Subject: James A. FitzPatrick Nuclear Power Plant  
Docket No. 50-333  
Fire Protection System

We are enclosing additional information in response to various NRC staff concerns on the JAF Fire Hazards Analysis. These responses are consistent with your request in the JAF Safety Evaluation Report supporting Amendment No. 47 to Facility Operating License No. DPR-59 dated August 1, 1979.

JAMES A. FITZPATRICK NUCLEAR POWER PLANT  
FIRE HAZARDS ANALYSIS  
SUPPLEMENTAL DOCKET NO. 50-333

SK. SER 3.1.0-2

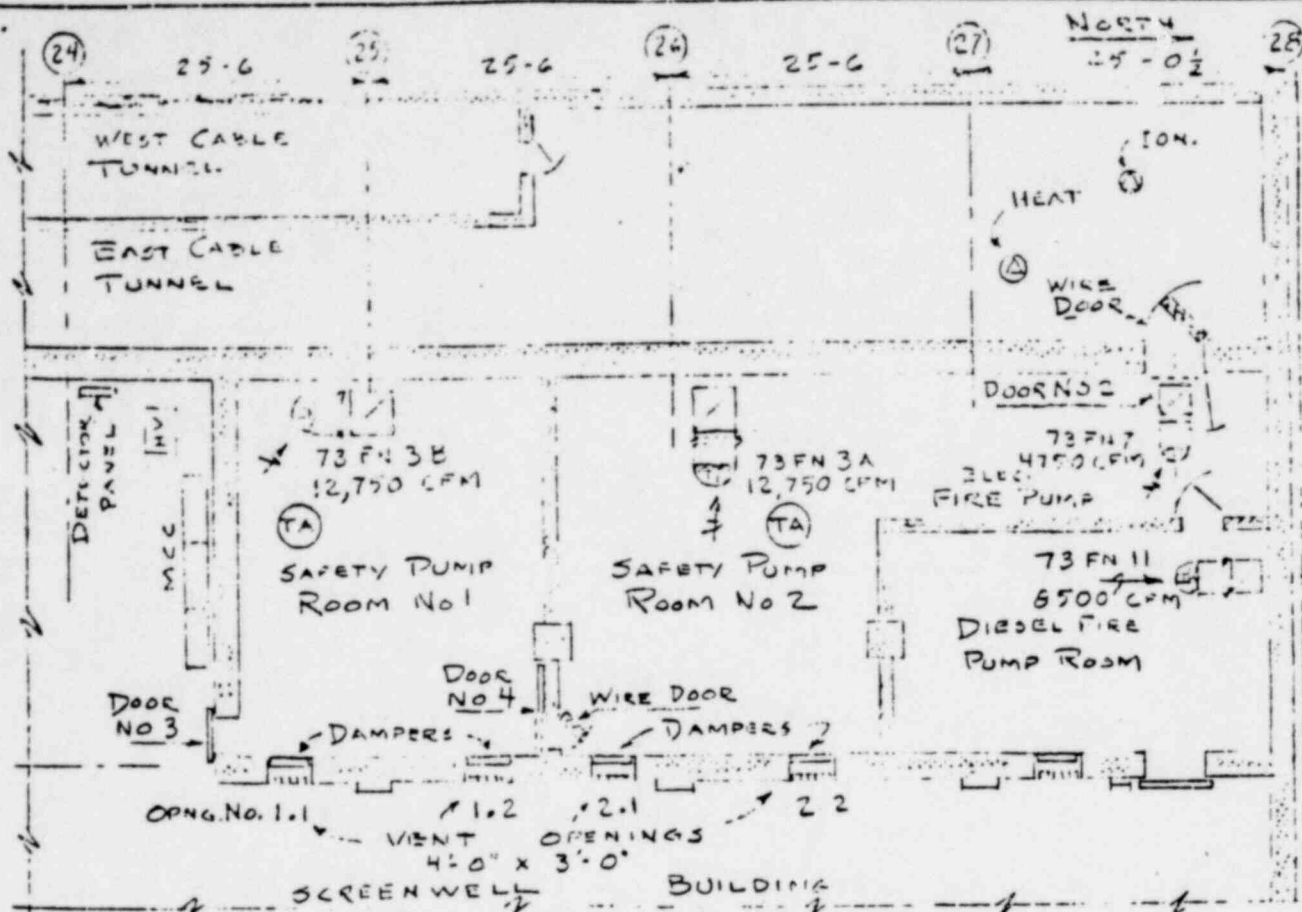
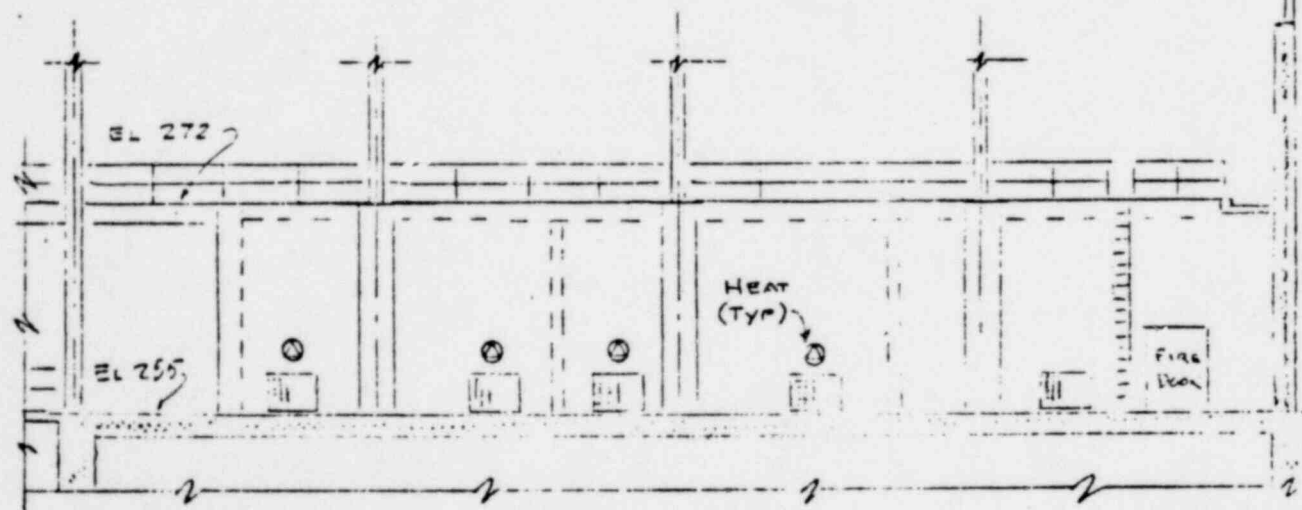
The safety related pump rooms SP1 and SP2 contain cables and equipment required for shutdown and cooldown of the plant. It is the staff's concern that a fire in the screenwell area would be drawn into the rooms through unprotected ventilation openings by the rooms ventilation systems.

Provide physically separated supply ventilation systems, with automatically actuated 3 hour fire rated dampers, for Safety Related Pump Rooms SP1 and SP2.

A separate source of ventilation air will be provided from the east cable tunnel via the existing access doorways. The access door between the pump rooms and the door to the east cable tunnel will be held open with fusible links and electric releases. The four existing ventilation openings to the pump rooms will be fitted with 3 hr rated fire dampers equipped with standard 160 F fusible links and electric releases. With this configuration, air can be drawn from either the screenwell building or the cable tunnel to supply makeup air removed by the exhaust fans.

Both doorways will be fitted with new heavy gauge steel wire mesh doors for security purposes and equipped with electronic supervision. The attached sketch shows the locations of the proposed fire dampers and the wire mesh doors.

The electric releases for the two doors and the four dampers will be actuated automatically by heat or smoke detectors or remote manually from a local control panel. The fusible links will serve as back-up for the electric releases.

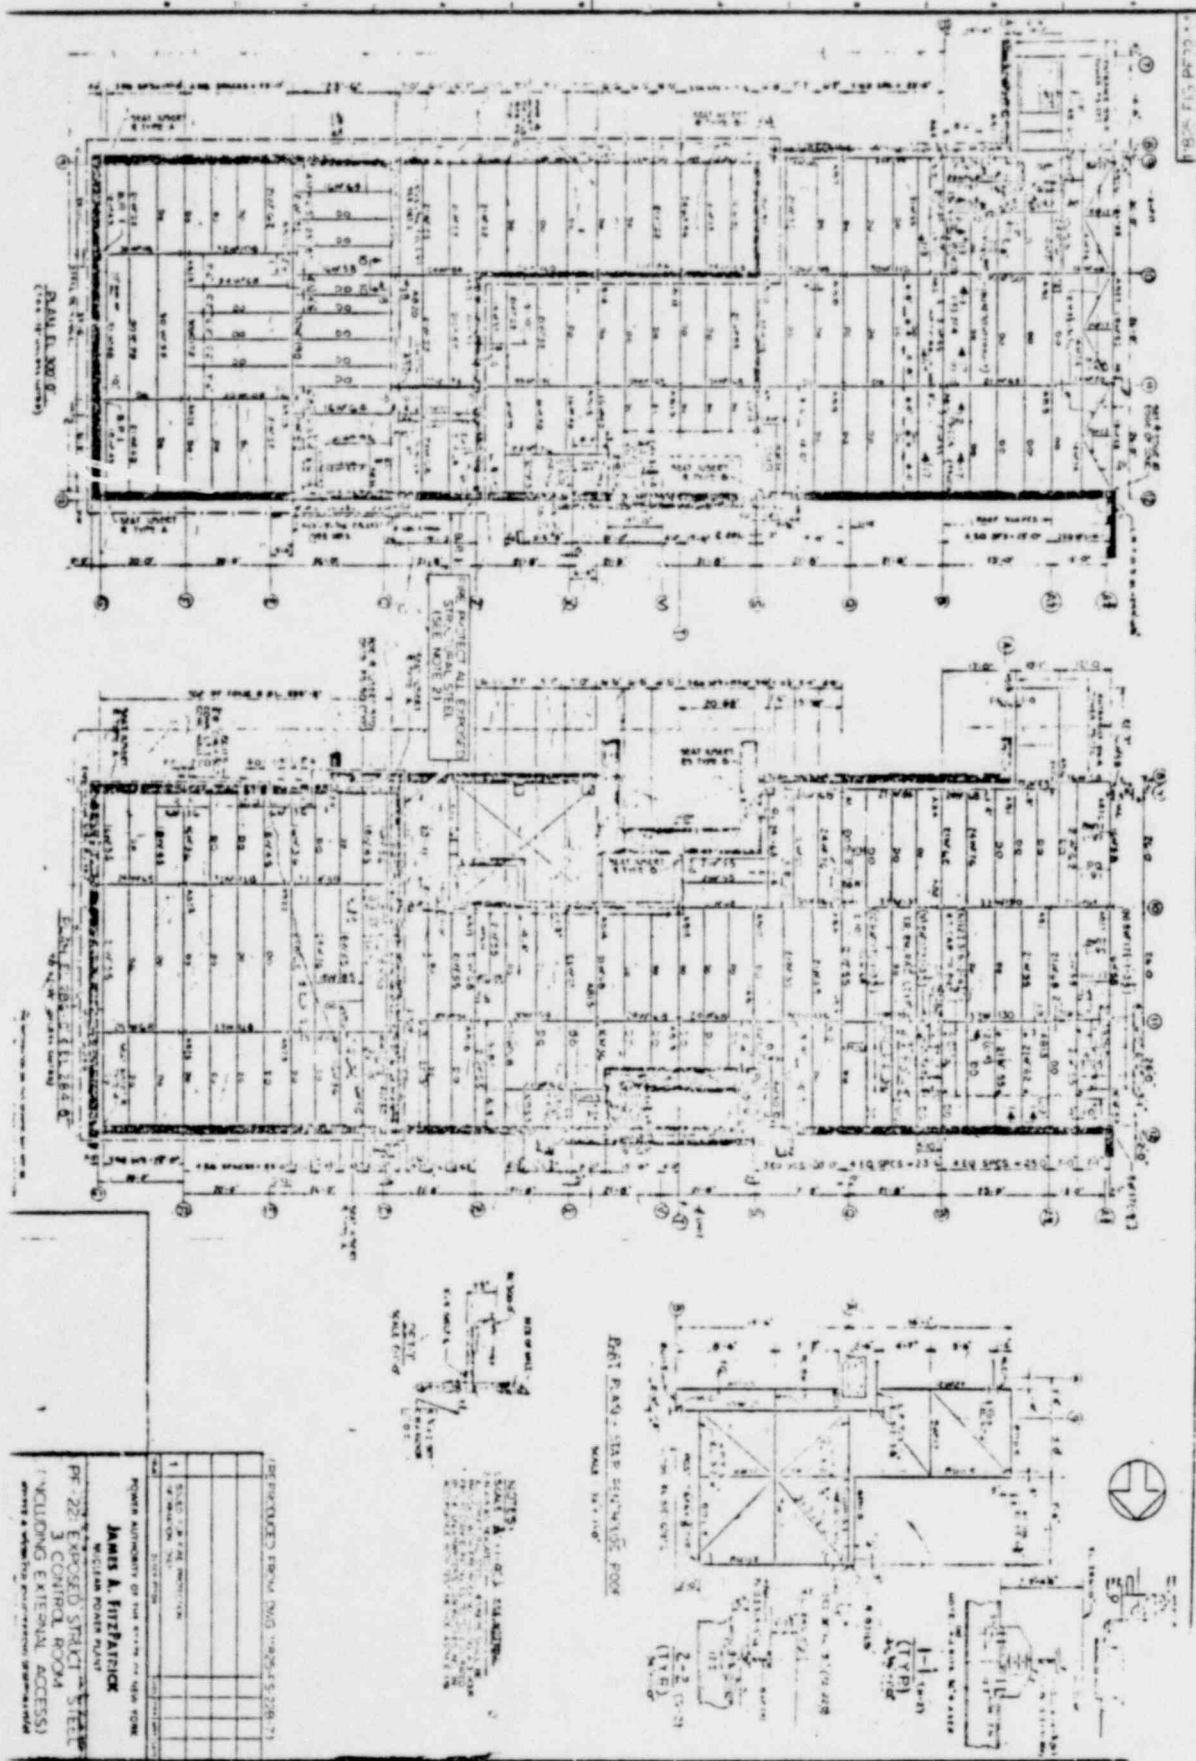
In August 3, 1978 response to Staff Request No. 20, the licensee identified several plant areas where exposed structural steels exist, and provided general statements of the licensee's conclusion in regard to the safe shutdown consequences of fire damage to structural steel members in these areas. The responses, however, did not provide any information which could enable the staff to evaluate the validity of such conclusion.

Exposed structural steels should be protected against the fire damage unless it can be demonstrated that the failure of such steels would not jeopardize safe shutdown capability of the plant.

Conclusion: The roof support beams will be fire protected for a 3 hr fire resistance rating. This protection will sustain the roof slab and the fire barriers between modules so that a fire in one module will not damage the other module. Refer to 11825-FIG-PF22-2 for a delineation of the steel requiring fire protection.

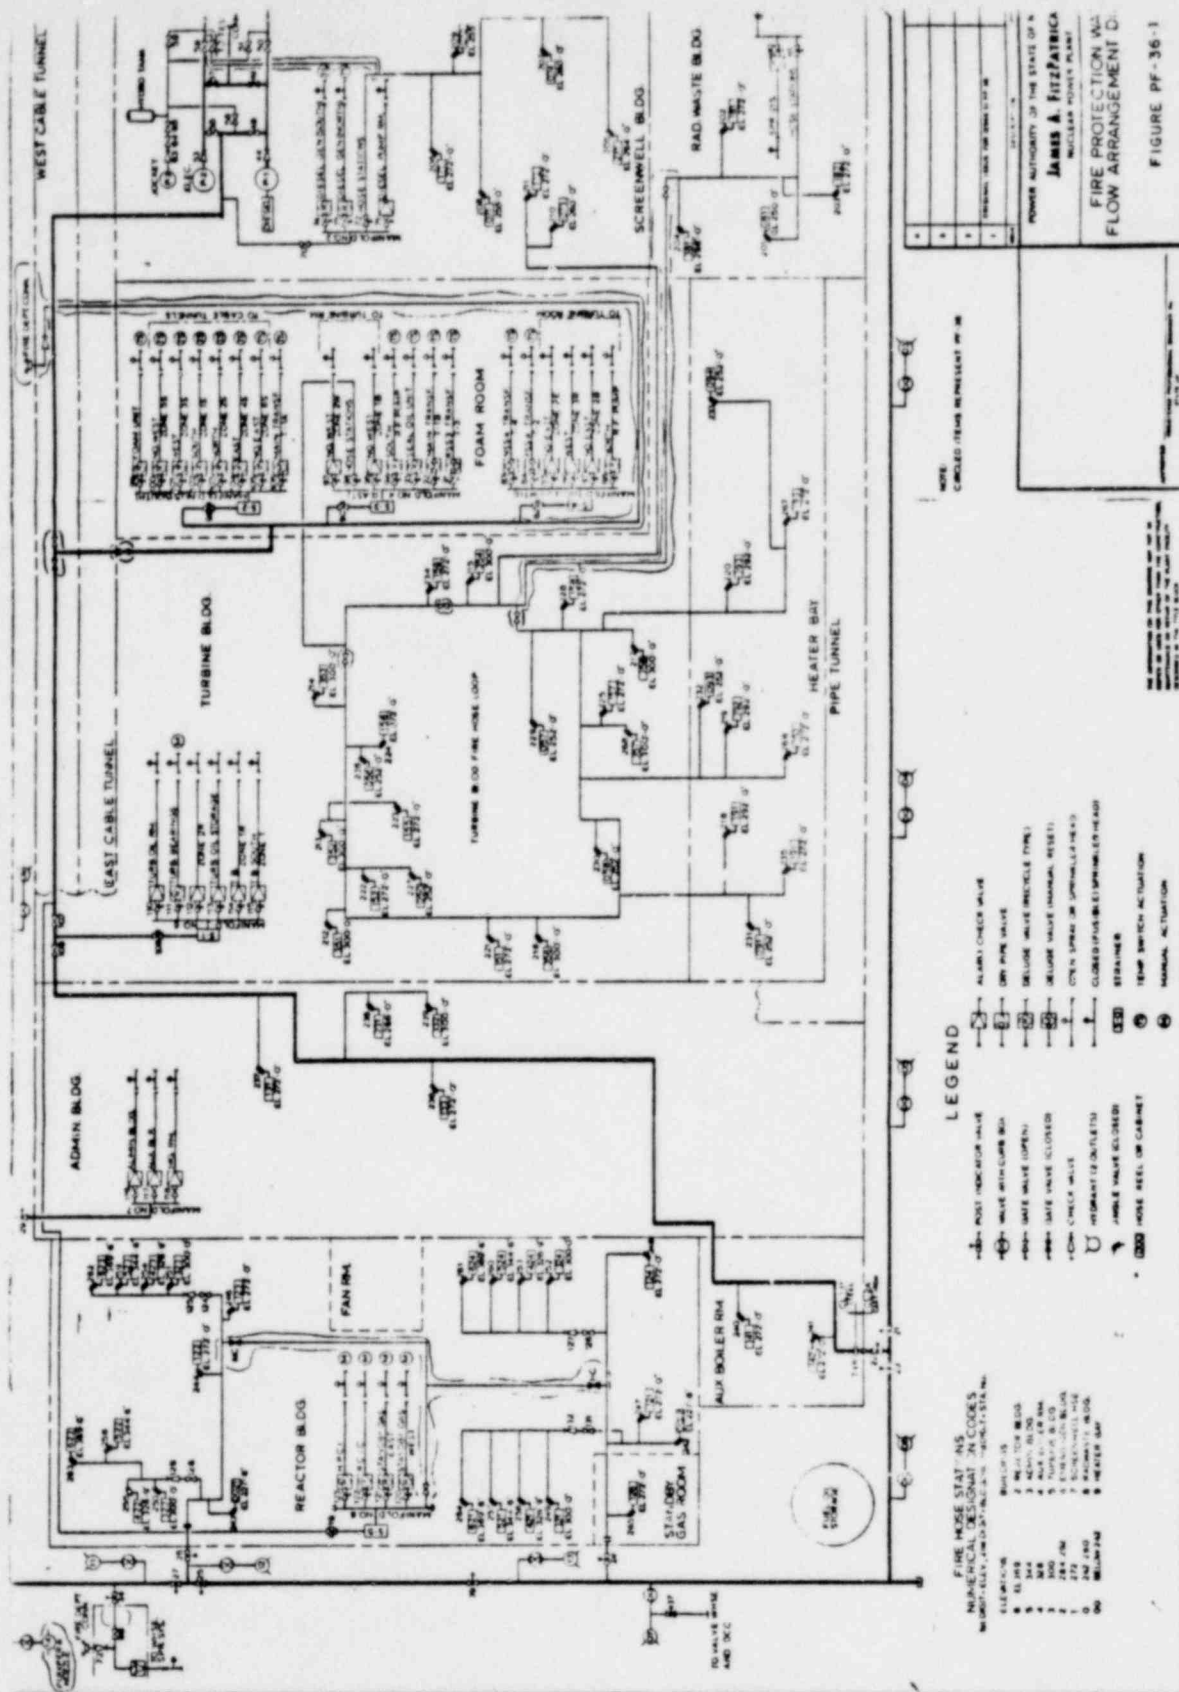
Because of the pipe layout and valve arrangement in the fire water supply system, a single failure can impair the ability to supply fire suppression water to the automatic water suppression systems and backup manual hose stations in some areas of the plant.

A separate redundant connection should be provided from the underground fire main to each subsystem such that a single failure in the piping system will not cause a loss of all fire suppression water to any safety related fire zone.

Piping will be extended into an internal grid system with sectionalizing valves. Independent redundant fire water supplies (fixed suppression or hose stations) are available to all safety related areas and arranged such that a single failure will not cause the loss of all suppression water. The 12-inch internal header will be considered an extension of the yard loop as allowed by paragraph 3(a) of BTP APCSB 9.5-1 Appendix A.

One fire department connection similar to the one on the warehouse will be provided outside the turbine building. If water is not available to the fire protection headers in the foam room from the 12 inch internal header, two 2 1/2 inch hoses can be run from hydrant No. 08 to the fire department connection to supply the headers from the yard loop.

As further protection against complete loss of fire protection water, hydrant No. 14, which is connected to the 8 inch city water main, will be replaced with a municipal type hydrant having a 4 1/2 inch pumper nozzle. Also, the present check valve number 78 in the warehouse will be removed. In the event both fire pumps were out of service, or if supplementary water beyond the capacity of the pumps is required, a fire department pumper truck could take suction from the city water main and supply any part of the entire system.
